ENGINEERING CHANGE NOTICE

Proj. ECN W-105-172

2. ECN Category (mark one)	3. Originator's Name, Organization, MSIN, and Telephone No.		4. Date
Supplemental ☒	K.L. EWER, KEH, E6-04, 6-1294		3-19-92
Direct Revision ☐	5. Project Title/No./Work Order No. W-105/ 242-A EVAP RETTN BASINS	6. Bldg./Sys./Fac. No. 242-AL	7. Impact Level / SC 3EQ / 3
Change ECN ☐			
Temporary ☐			
Supersedure ☐	8. Document Number Affected (include rev. and sheet no.) SEE BLOCK 12	9. Related ECN No(s). SEE BLOCK 12	10. Related PO No. N/A
Discovery ☐			
Cancel/Void ☐

13a. Justification (mark one)	13b. Justification Details
Criteria Change ☒	ITEMS 9, 12-17; LOI 93 - DIRECTS KEH TO PROVIDE LEAK DETECTION INSTRUMENTATION AT CATCH BASINS WITH LOCAL ANNUNCIATION & ALARM AT 242-A EVAP.
Design Improvement ☐	
Environmental ☐	
As-Found ☐	ITEMS 1-8, 10-19; LOI 95 - PROVIDE CONTINUOUS LIQUID LEVEL INSTRUMENTATION FOR BASINS (6" NORTH SAMPLE PORT RISER) AND LEACHATE SUMPS (4" LEACHATE RISER) WITH LOCAL READ-OUT & 242-A ALARMS
Facilitate Const. ☐	
Const. Error/Omission ☐	
Design Error/Omission ☐

Ref. Dwg. H-2-79581 | Sh. 1 | Rev. 0 | Prepared By K.L. EWER | Checked By | ECN No. W-105-172 | Page 4/4

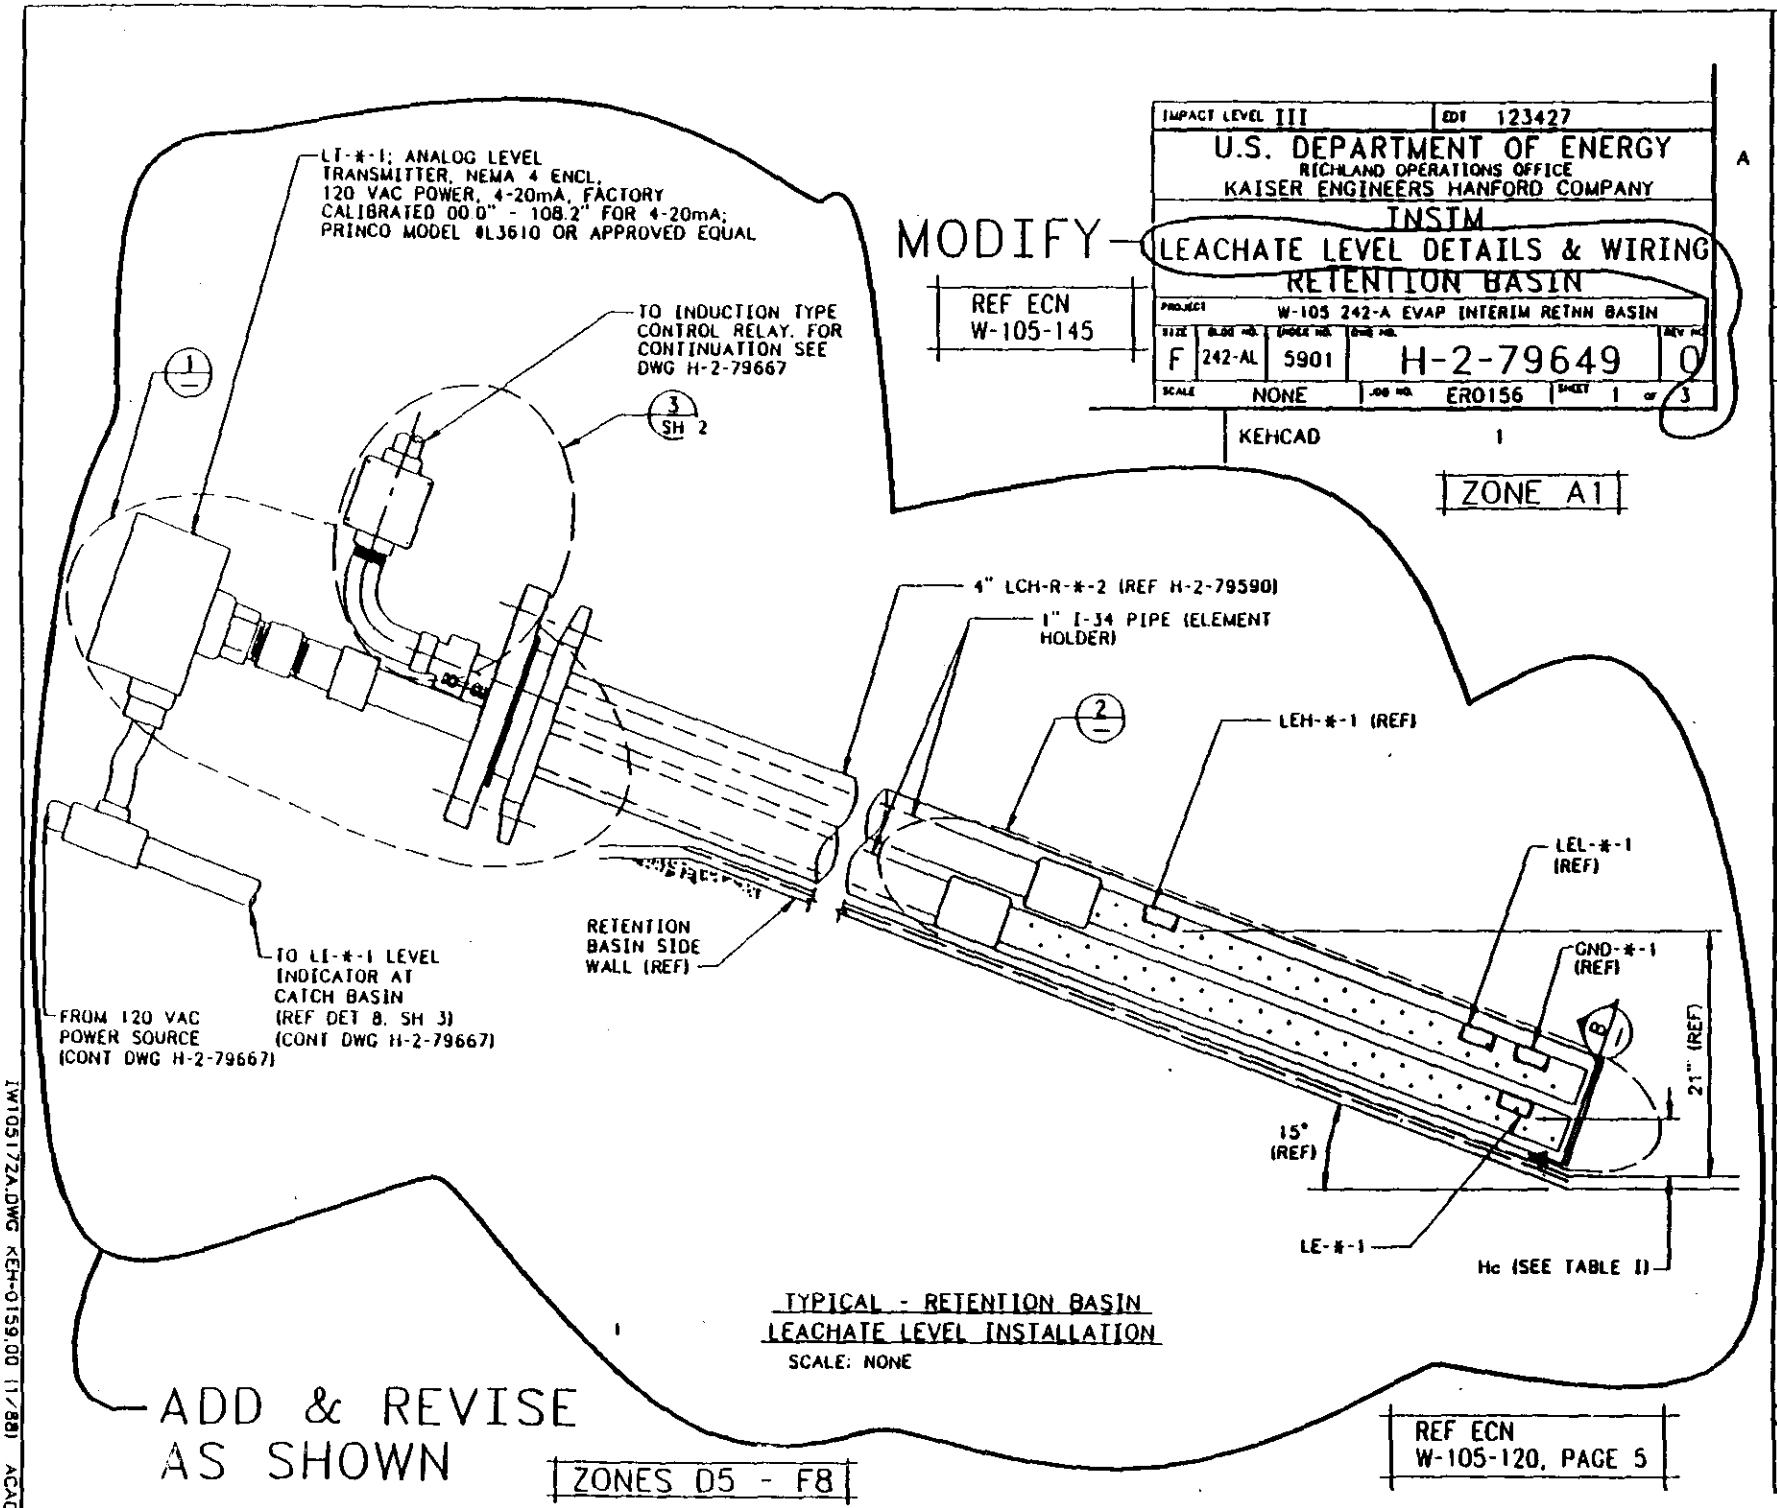
1. REVISE DRAWING LIST PER PAGE 4.

REVISE AS SHOWN

ADD

Ref. Dwg.	Sh.	Rev.	Prepared By	Checked By	ECN No.	Page
H-2-79649	1	0	K.L.EWER		W-105-172	5/22

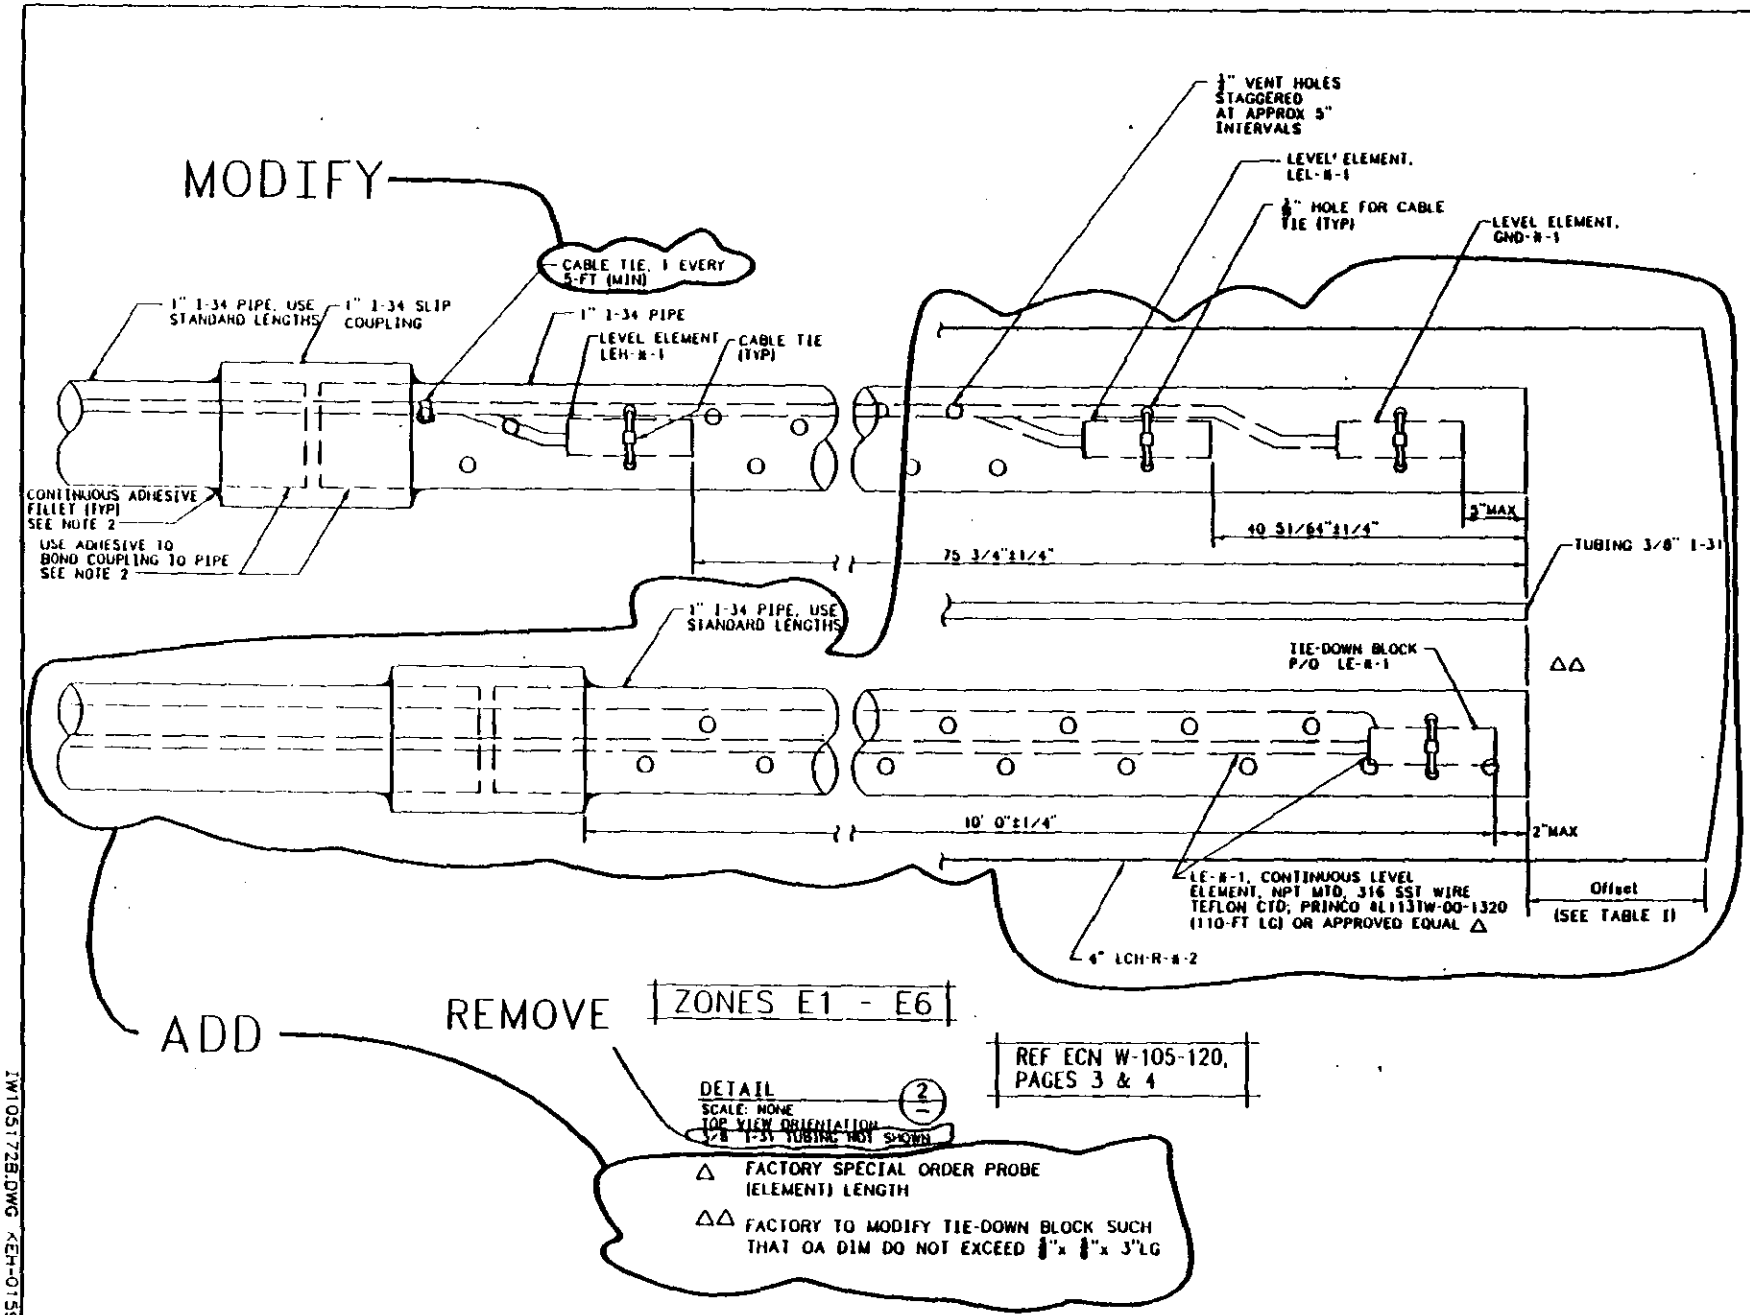
2. REVISE TITLE BLOCK & INSTL DETAIL PER PAGE 5.
3. REVISE DETAIL 2 PER PAGE 6.
4. REVISE DETAIL 1, VIEW B & SECTION A PER PAGE 7.
5. ADD NOTE AS FOLLOWS: " 7. OPERATIONS AND MAINTENANCE MANUAL AND SPARE PARTS LIST WILL BE PROVIDED FOR LE-*-1&-2, LI-*-1&-2, LT-*-1&-2 AND LDE-*-1&-2."

KAISER ENGINEERS HANFORD	ENGINEERING CHANGE NOTICE SKETCH					
Ref. Dwg.	Sh.	Rev.	Prepared By	Checked By	ECN No.	Page
H-2-79649	1	0	K.L.EWER		W-105-172	7/22

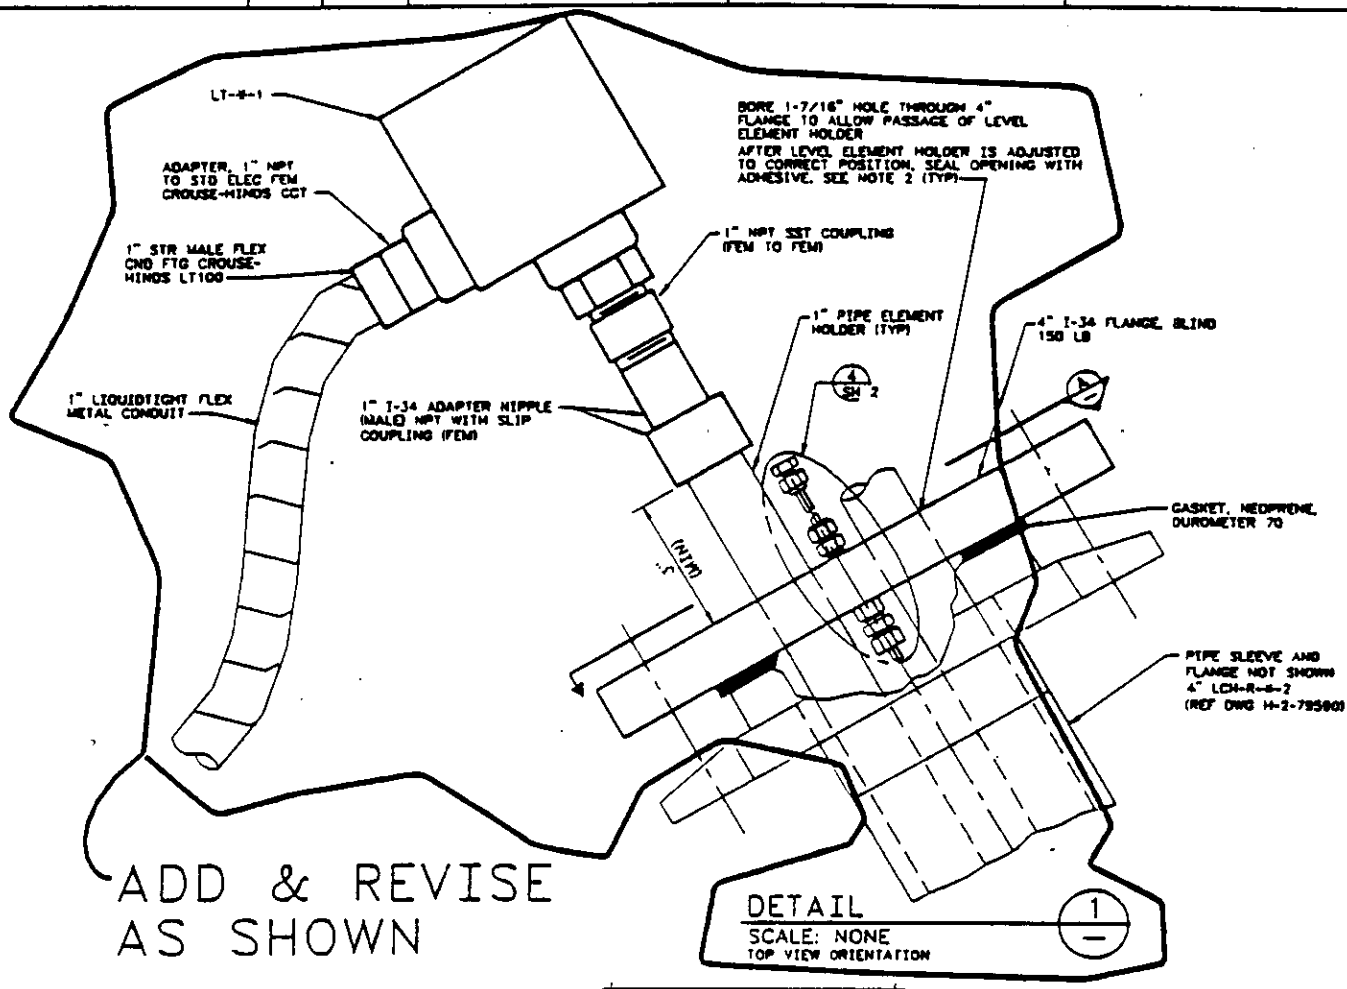
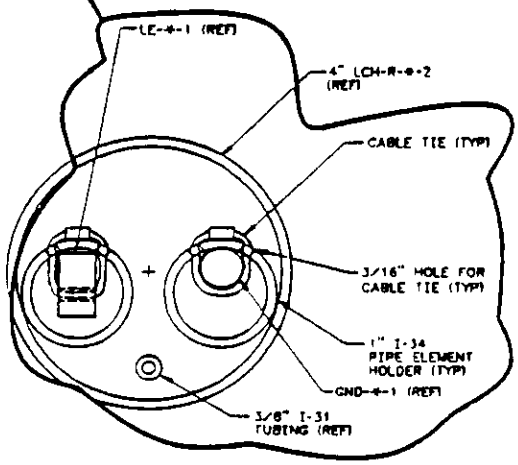
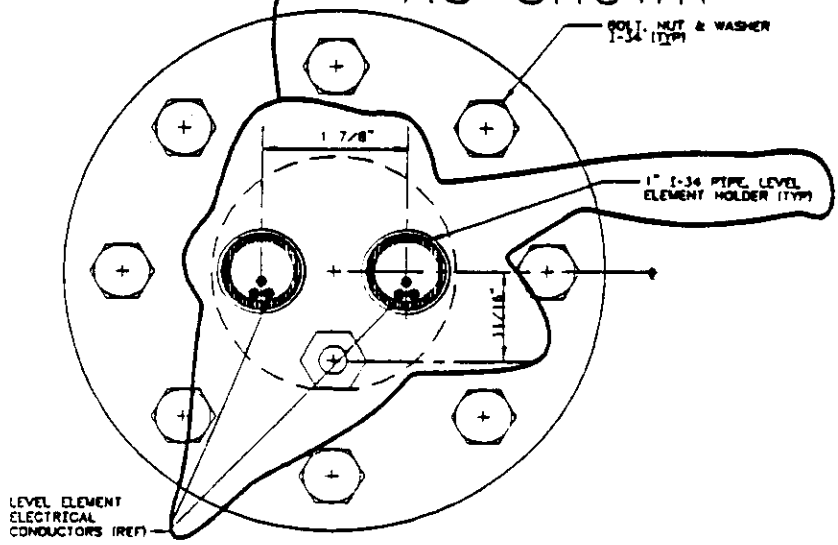
ADD & REVISE AS SHOWN

DETAIL 1
SCALE: NONE
TOP VIEW ORIENTATION

ADD & REVISE AS SHOWN

VIEW B
SCALE: NONE
ZONE B5

ADD & REVISE AS SHOWN

SECTION A
SCALE: NONE
ZONES A6 - C8

Ref. Dwg.	Sh.	Rev.	Prepared By	Checked By	ECN No.	Page
H-2-79649	1	0	K.L.EWER		W-105-172	8/22

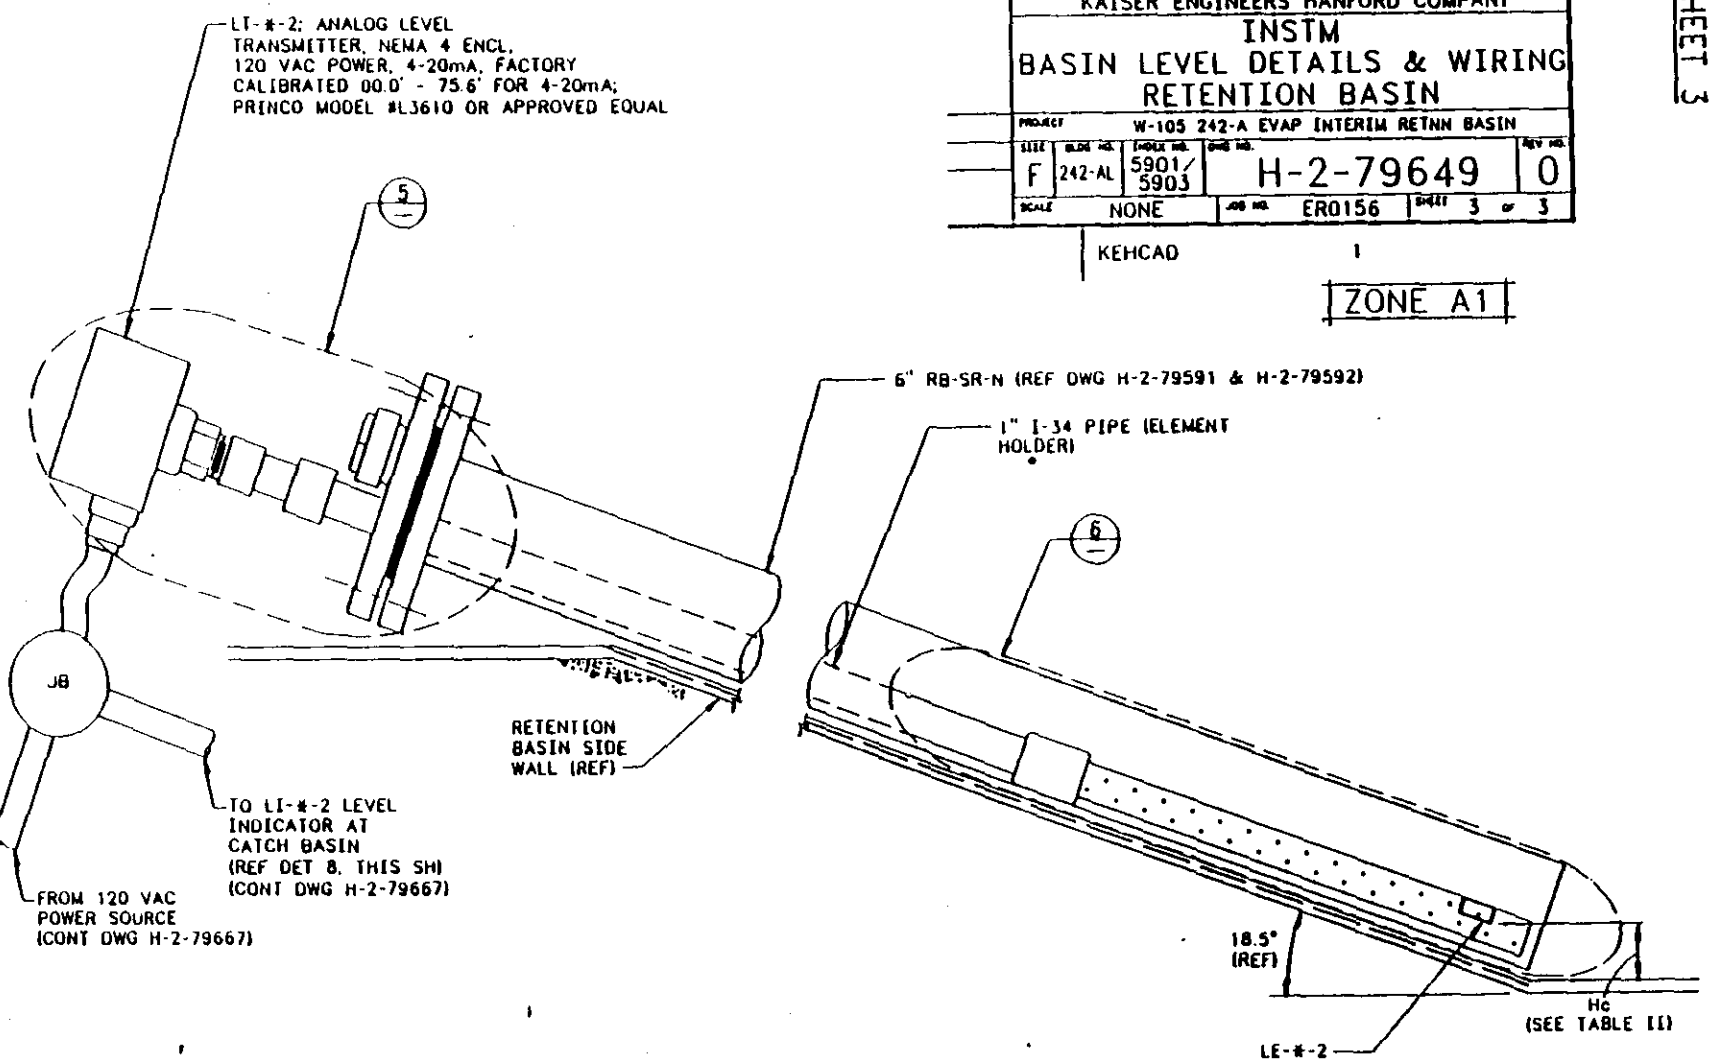
6. TITLE BLOCK & INSTL DETAIL PER PAGE 8.
7. DETAIL 6 PER PAGE 9.
8. DETAIL 5, DETAIL 10 AND SECTION C PER PAGE 10.
9. BASIN LEVEL INTERCONNECTION DIAGRAM PER PAGE 11.
10. DETAIL 7 CATCH BASIN LDE MOUNTING PER PAGE 12.
11. DETAIL 8 LEACHATE/BASIN LEVEL IND PER PAGE 13.
12. ADD REFERENCE TO TITLE BLOCK REFERENCES AT ZONE A4; "HPS I-2-7 HANFORD PLANT STANDARD - EQUIPMENT NAMEPLATES"
13. TABLE I AND TABLE II PER PAGE 22.

ADD TO NEW SHEET 3

TYPICAL - RETENTION BASIN
N. SAMPLE PORT/BASIN LEVEL RISER INSTALLATION
SCALE: NONE

DETAIL 6/—
SCALE: NONE
TOP VIEW ORIENTATION

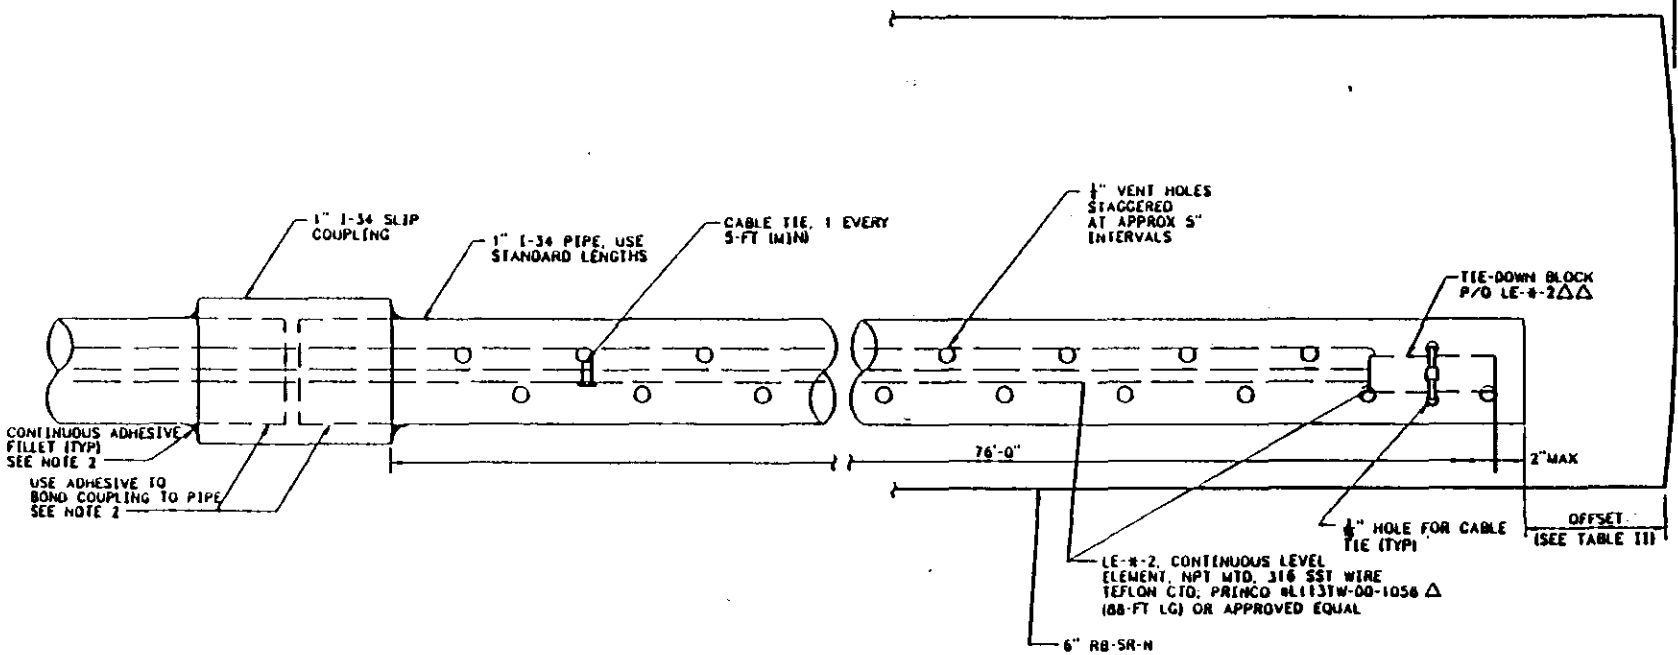
ADD TO NEW SHEET 3

Δ FACTORY SPECIAL ORDER PROBE (ELEMENT) LENGTH

ΔΔ FACTORY TO MODIFY TIE-DOWN BLOCK SUCH THAT OA DIM DO NOT EXCEED 1/4"x 1/4"x 3"LG
